NY FEMA R2 – WUID#214093 USGS FEEDBACK

Hydro Flattening Issue

USGS provided feedback for WUID#214093 on various issues related to hydroflattening, misclassification, withheld points and geometry errors using NY_FEMAR2_Central_3_2018_2021-08-04_Errors.gpkg and supplemental report files received 08/04/2021 for the deliverables submitted by Dewberry on 03/26/2021.

Error Call Feature id: 113

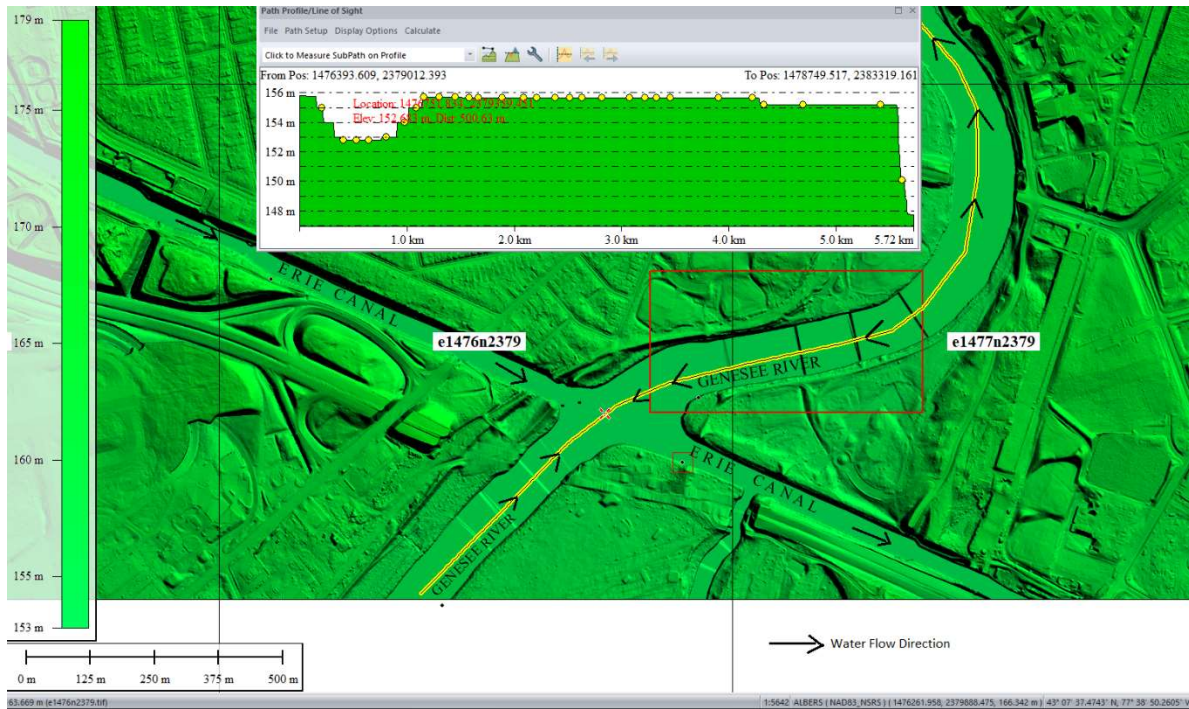
While reviewing the errors and performing corrections on the data, Dewberry observed an unusual monotonicity issue for error call id-113 for hydro breakline causing geometry / hydroflattening of DEM on tile ids : e1476n2379 and e1477n2379.

DELIV_TYPE	DELIV_ID	TYPE	SUBTYPE
Hydroflattened Polygon Breaklines	7556	Geometry Error	Downstream Constraint

On further review of the error call and monotonicity issue at the location, Dewberry observed that the issue extends beyond the two tiles identified due to temporal variation of the water levels maintained in the Erie Canal during the lidar acquisition period. As the monotonicity was maintained in the Erie Canal for the deliverables submitted on 03/26/2021, Genesee River was shown as water flows in opposite direction from the northern section of the river at the Erie Canal intersection.

To mitigate the issue and maintain monotonicity for the Erie Canal and Genesee River, Dewberry collected Erie Canal hydro breakline with 155.350 m elevation based on the acquisition date 05/09/2019 and swaths east of West Guard Gate (04/25/2019) to align with rest of the canal elevation. This approach resolved the issue with downstream constraint occurring for Genesee river at the intersection of Erie Canal. The Erie Canal polygon width was expanded to match with canal walls / terrain. Water drained out / temporal change segment with 152m elevation (swaths collection date 04/25/2019) of the hydrographic polygon was created as a separate feature class and attributed with appropriate comments in the feature class attribute table. Dewberry classified the lidar points on the temporarily exposed canal walls of this impacted section between 152 m -155.350 m in elevation as Class-32.

Profile view of Swaths flown on 04/25/2019 and 05/09/2019

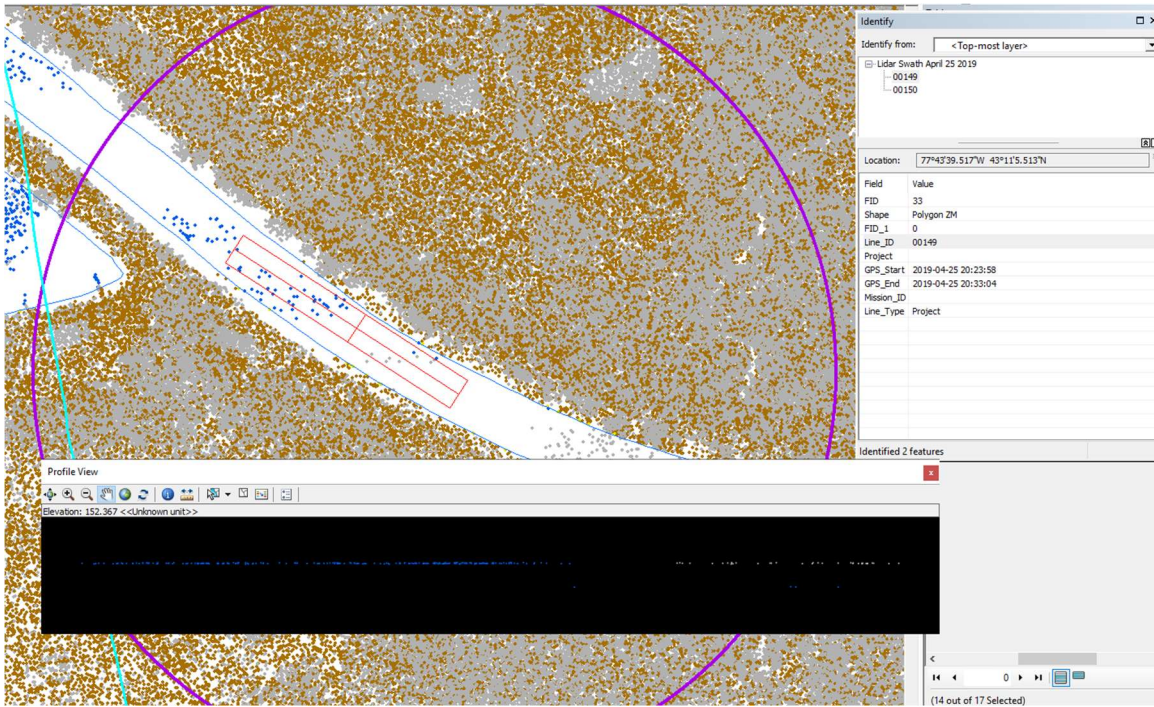
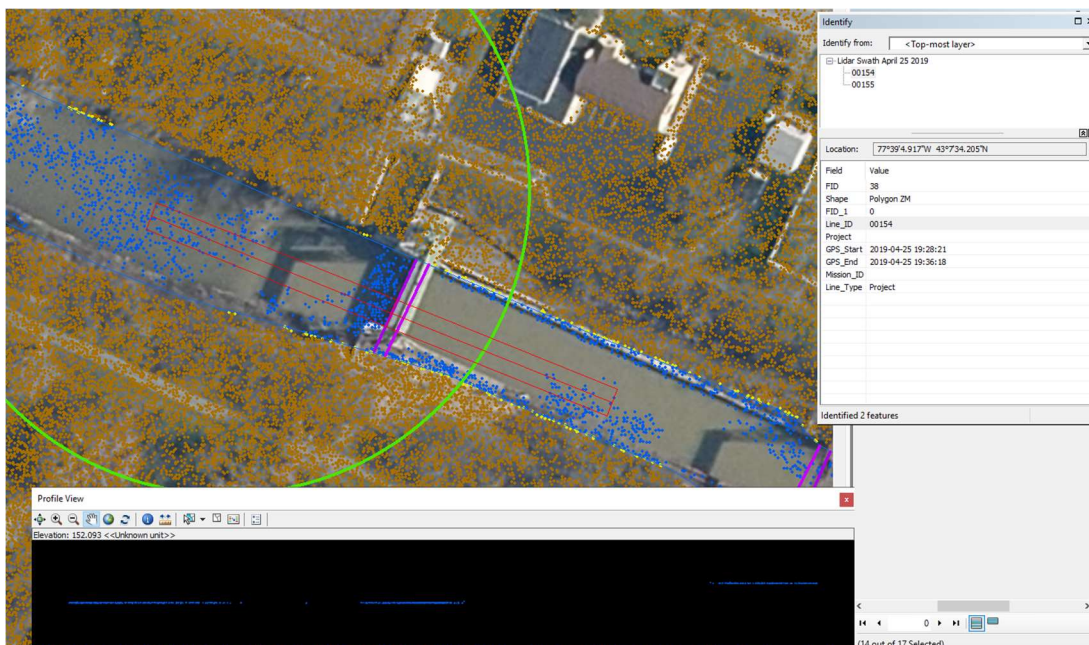
Based on the lidar acquisition dates and point cloud data, the water elevation in the Western Erie Canal is at approximately 152 meters for the swaths (PSID 149 thru 155) acquired on 04/25/2019 up to the physical barrier feature West Guard Gate on Erie Canal. Water Level is approximately 155 meters for the swaths (PSID 136 thru 148, and reflight 10149) acquired on 05/09/2019. Temporal variation of 3 meters is occurring at 77°43'39.517"W 43°11'5.513"N (PSID 149).
